**Site Formation and Infrastructure Works
for Public Housing Development near Tan Kwai Tsuen,
Yuen Long – Investigation, Design and Construction**

**FINAL PRELIMINARY
ENVIRONMENTAL
ASSESSMENT REPORT**

199086/BIN/103/Issue 1
March 2023

RESPONSE TO COMMENTS RECORDS

Drawing No. Figure 6.2

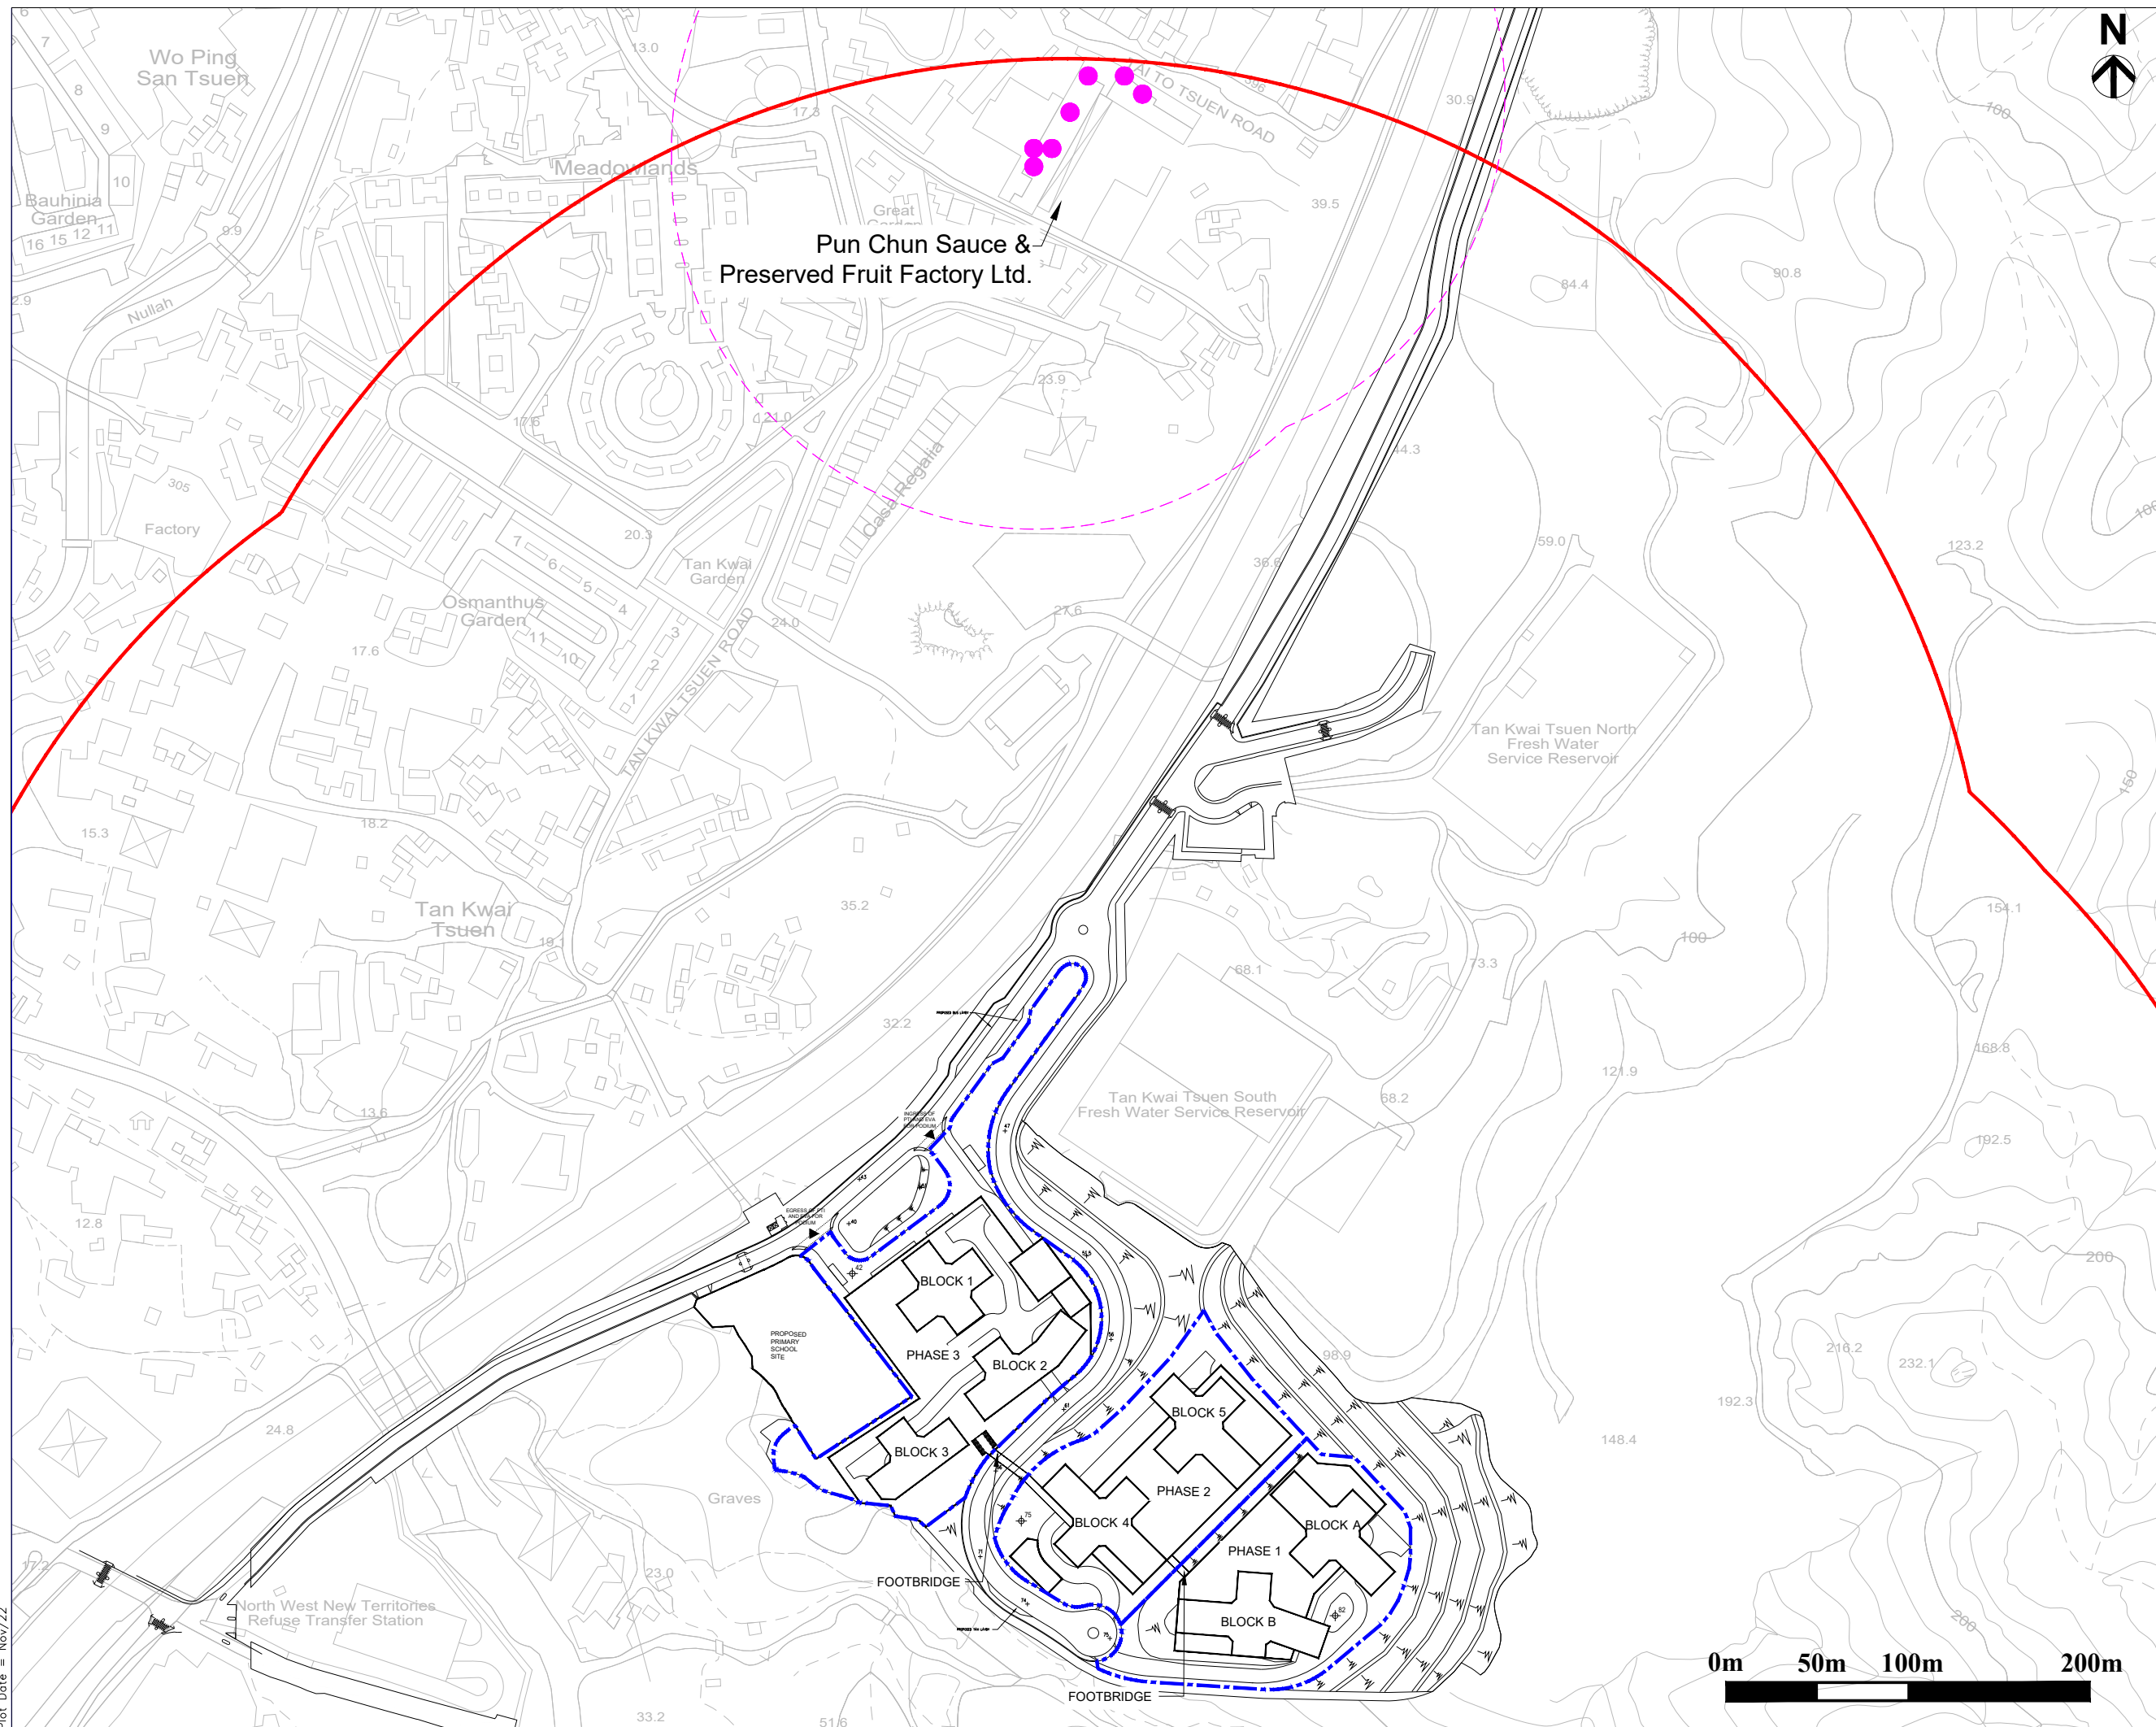
10. Figure 6.2 Please highlight the area of the proposed development which located within 200m from the NWNT RTS and mark clearly that no air-sensitive uses including openable window, fresh air intake and recreational use in the open space would be located within this area.	Figure 6.2 has been revised to highlight the area of the proposed development which located within 200m from the NWNT RTS. It has been marked in the legend that no air-sensitive uses including openable window, fresh air intake and recreational use in the open space would be located within the area.
Further to my previous email dated 2022/08/26, below please find the comments from Noise perspective:
